PREVOST

WARRANTY BULLETIN

WB24-30

DATE :	September 2024	SECTION:	06 ELECTRICAL
EXPIRATION:	September 2026		
SUBJECT:	REORGANIZING CONDENSER FAN POWER DISTRIBUTION

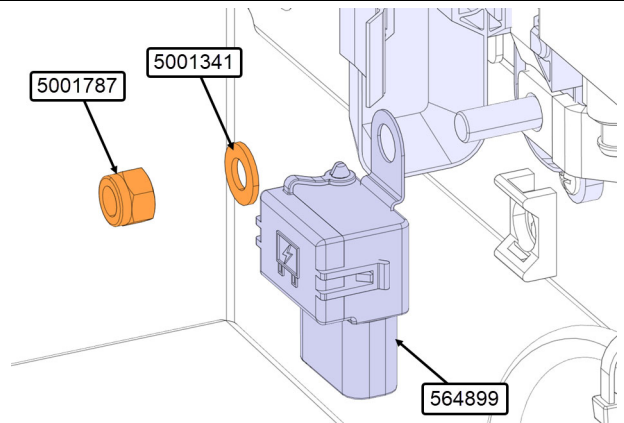
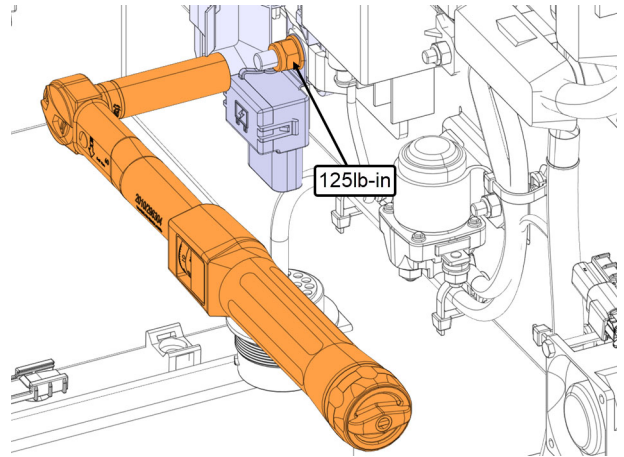
12. Install the new fuse holder 564899 on fuse holder **F209** with nut 5001787 and washer 5001341.

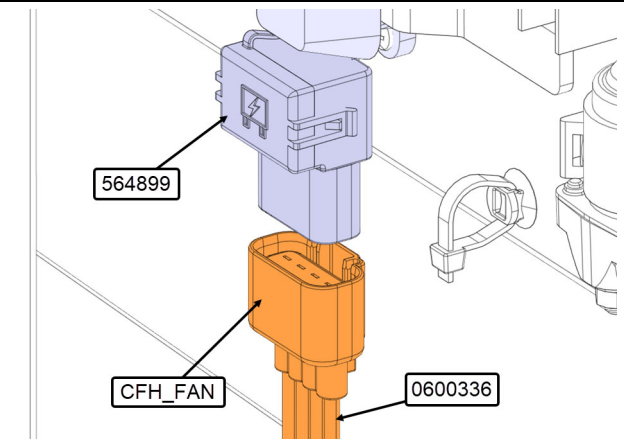
16. Plug the connector **CFH_FAN** of the harness 0600336 to the fuse holder 564899.

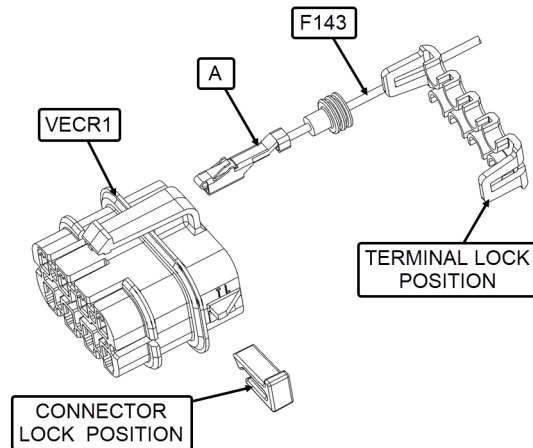
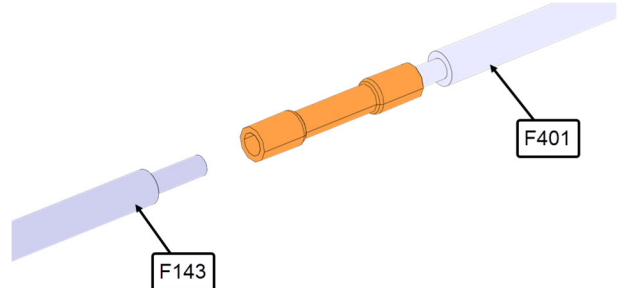
19. Remove the connector lock position of connector **VECR1**.
 20. Disconnect **VECR1**.
 21. Remove the terminal lock position of the connector **VECR1**.
 22. Remove the terminal **F143** at position **A** of connector **VECR1**.
 23. Reinstall the terminal lock position of the connector **VECR1**.
 24. Reconnect **VECR1**.
 25. Reinstall the connector lock position assurance of connector **VECR1**.

26. Remove the terminal of **F143**.
 27. Connect the wire **F143** to butt splice **F401** of new harness 0600336.
 28. Heat the butt splice shrink sleeve.

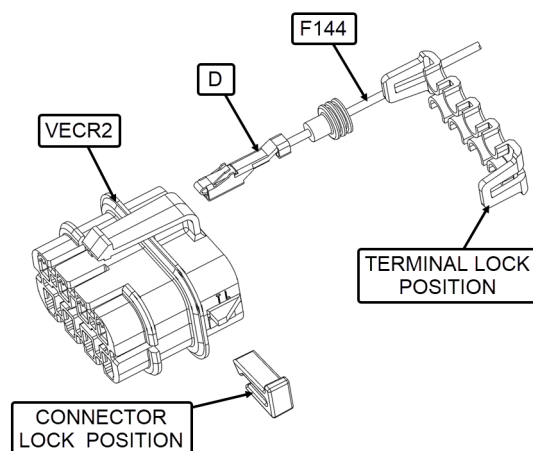
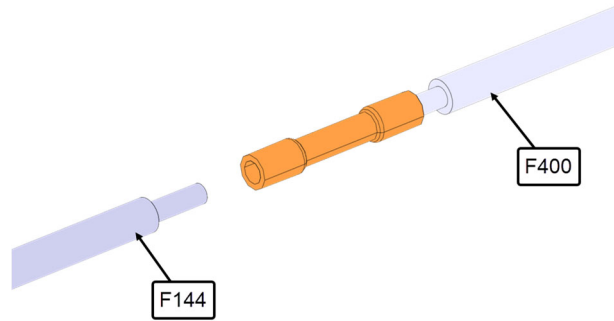
29. Remove the connector lock position of connector **VECR2**.
 30. Disconnect **VECR2**.
 31. Remove the terminal lock position of the connector **VECR2**.
 32. Remove the terminal **F144** at position **D** of connector **VECR2**.
 33. Reinstall the terminal lock position of the connector **VECR2**.
 34. Reconnect **VECR2**.
 35. Reinstall the connector lock position assurance of connector **VECR2**.

36. Remove the terminal of **F144**.
37. Connect the wire **F144** to butt splice **F400** of new harness 0600336.
38. Heat the butt splice shrink sleeve.

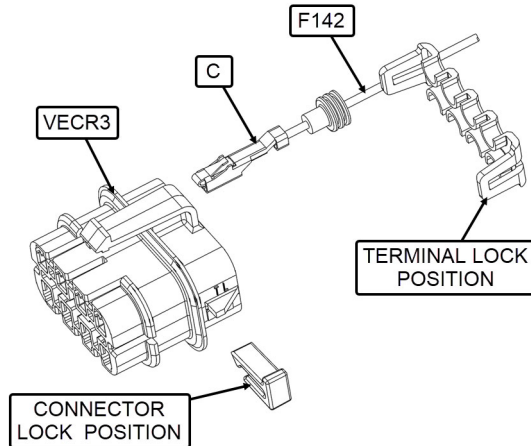
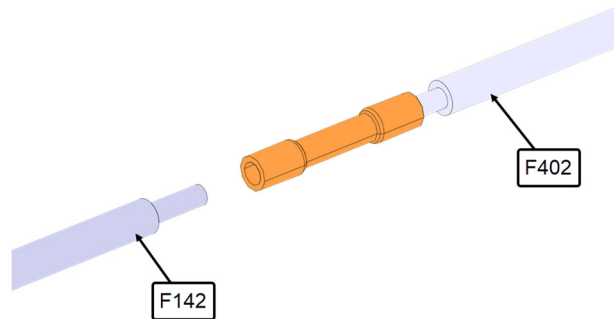
39. Remove the connector lock position of connector **VECR3**.
40. Disconnect **VECR3**.
41. Remove the terminal lock position of the connector **VECR3**.
42. Remove the terminal **F142** at position **C** of connector **VECR3**.
43. Reinstall the terminal lock position of the connector **VECR3**.
44. Reconnect **VECR3**.
45. Reinstall the connector lock position assurance of connector **VECR3**.

46. Remove the terminal of **F142**.
47. Connect the wire **F142** to butt splice **F402** of new harness 0600336.
48. Heat the butt splice shrink sleeve.

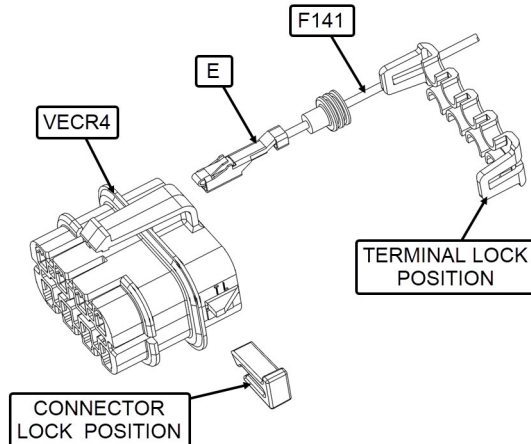
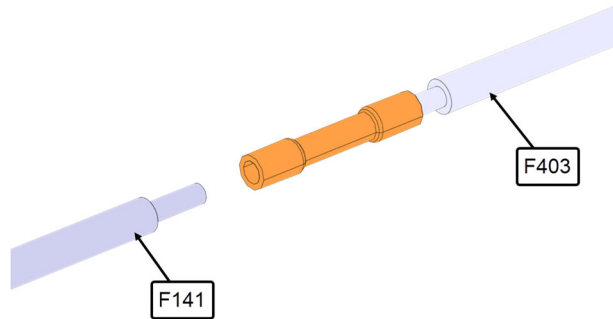
49. Remove the connector lock position of connector **VECR4**.
50. Disconnect **VECR4**.
51. Remove the terminal lock position of the connector **VECR4**.
52. Remove the terminal **F141** at position **E** of connector **VECR4**.
53. Reinstall the terminal lock position of the connector **VECR4**.
54. Reconnect **VECR4**.
55. Reinstall the connector lock position assurance of connector **VECR4**.

56. Remove the terminal of **F141**.
57. Connect the wire **F141** to butt splice **F403** of new harness 0600336.
58. Heat the butt splice shrink sleeve.

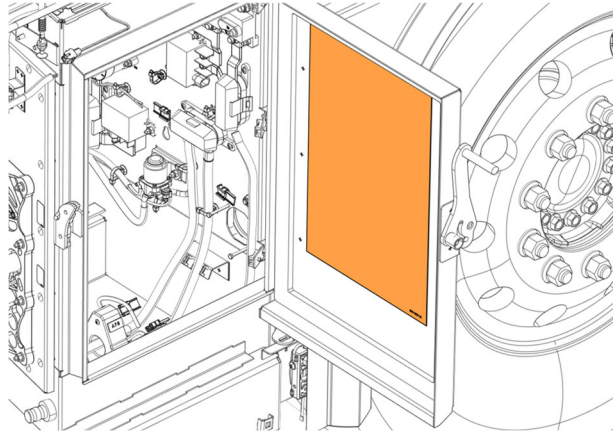
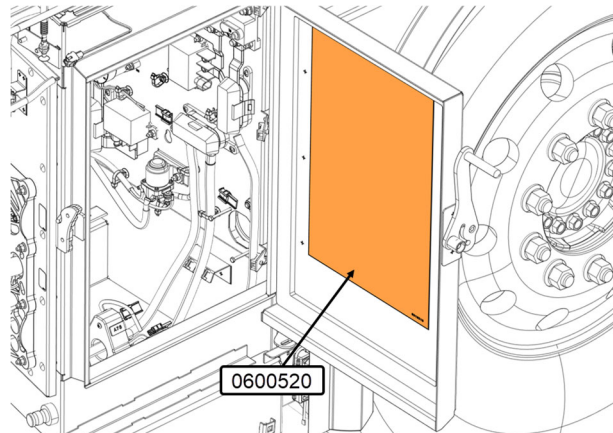
60. Remove the rear junction box components decal.

61. Install the new rear junction box components decal 0600520.
